MONTICELLO NUCLEAR GENERATING PLANT
Docket No. 50-263 License No. DPR-22

Revised Relief Request No. 16
Second Ten-Year Inservice Inspection Interval

RELIEF REQUEST # 16

MONTICELLO		UNIT 1
DWN: R. THORNE	FIGURE 2 REV. 1	
CHK'D: <i>GB</i>

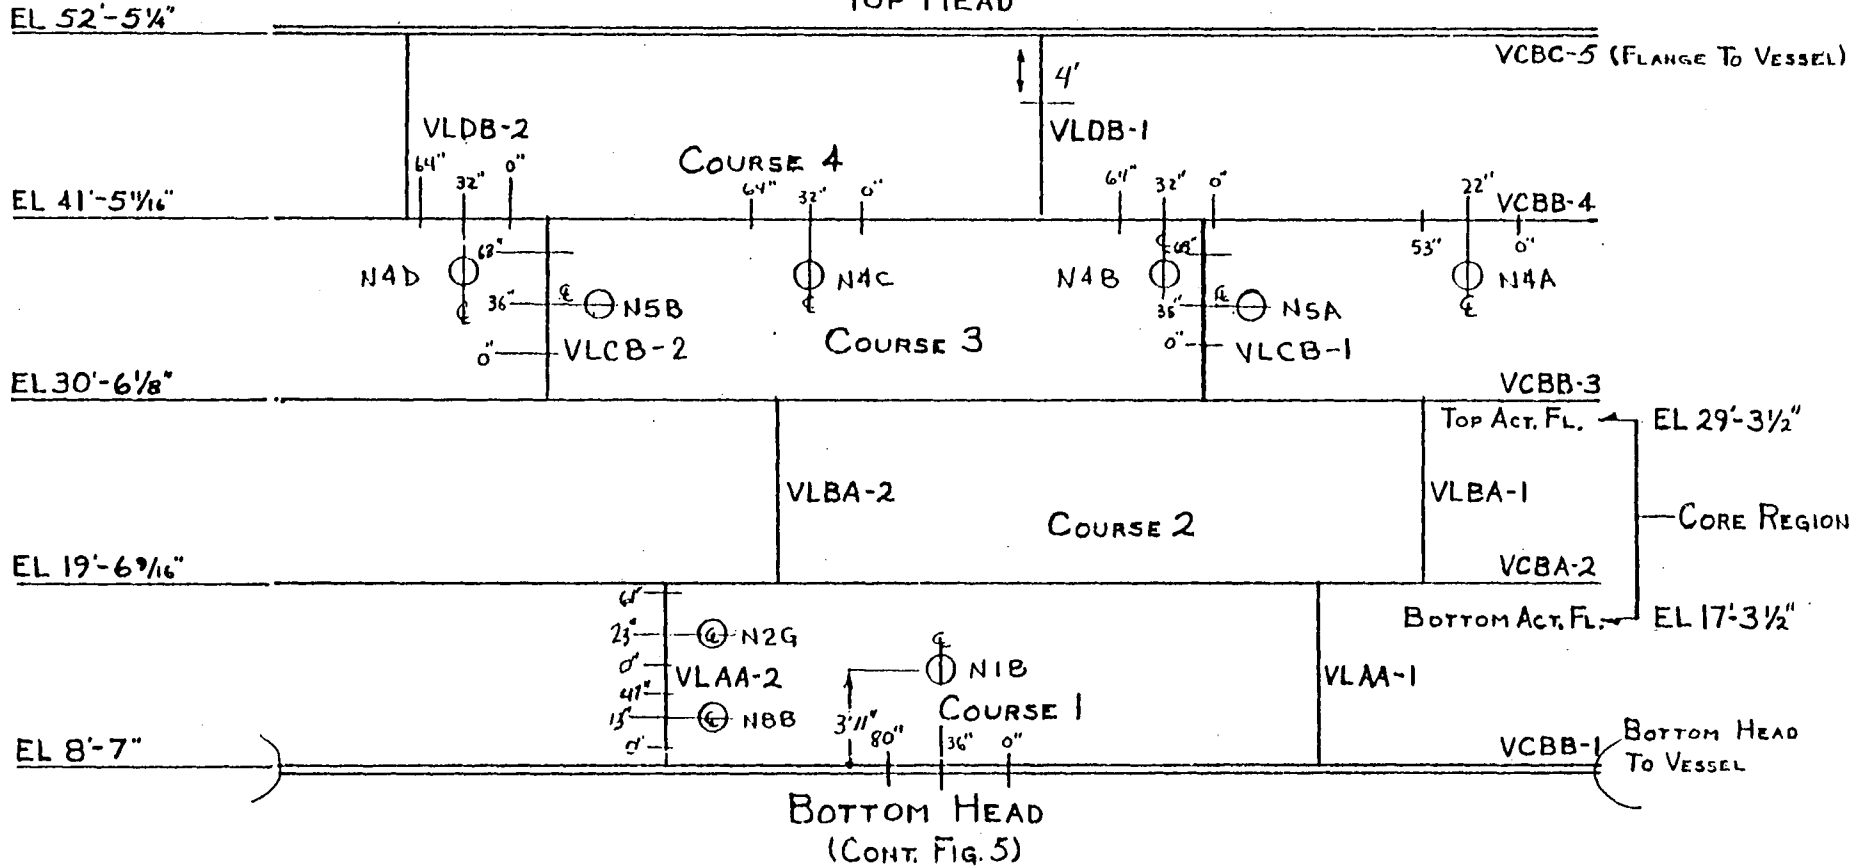
The requirement to perform a volumetric examination of 100% of one circumferential and one longitudinal weld is impractical.

Only limited O.D. access to beltline welds is available through the shield wall nozzle openings. Accessibility from the I.D. is limited using the present technology because of reactor vessel internals such as; core spray piping, feedwater spargers, guide rods, and obstructions welded to the shroud.

Specifically, one of the two longitudinal beltline welds is totally inaccessible because of welded obstructions on the shroud. The welded obstructions on the shroud also prevent the examination of two thirds of the circumferential beltline weld. In addition, portions of the vessel I.D. cladding is very rough and is unsuitable for ultrasonic examination.

VLBA-1: Clip welded to outside of Shroud at 45 degrees prevent tool access to entire weld.

VLBA-2: Interference from Jet Pumps.

VCBA-2: Clips welded to outside of Shroud at 45, 75, 105 and 315 degrees, Guide Rods at 0 and 180 degrees.

VLAA-1: Clip welded to outside of Shroud at 75 degrees prevents tool access to upper nine inches of weld. Lower 108 inches of weld inaccessible from vessel ID with present technology available today.

VLAA-2: Lower 108 inches of weld inaccessible with present technology available today. Upper 9 inches is only part of weld accessible from ID.

VCBC-5: Guide Rods at 0 and 180 degrees, Main Steam Line plugs and air hoses.

VLDB-1: Steam Dryer Support Brackets.

VLDB-2: Steam Dryer Support Brackets.

VCBB-4: Guide Rods at 0 and 180 degrees, Main Steam Line plugs and air hoses.

VLCB-1: Main Steam Line plugs and air hoses, Feedwater Sparger, Core Spray Piping.

VLCB-2: Main Steam Line plugs and air hoses, Feedwater Sparger, Core Spray Piping.

VCBB-3: Guide Rods at 0 and 180 degrees, Core Spray Piping, Feedwater Spargers, Surveillance Specimen basket. Rough cladding consisting of ground and unground areas limit the extent this weld can be examined.

Volumetrically examine one circumferential and one longitudinal beltline region weld to the extent practical. This would be 12 % of the circumferential beltline weld and 40% partial examinations of the accessible longitudinal beltline welds. In addition, perform a sampling volumetric examination of other longitudinal and circumferential reactor vessel welds to the extent practical. This amounts to 47% of the remaining reactor vessel welds.
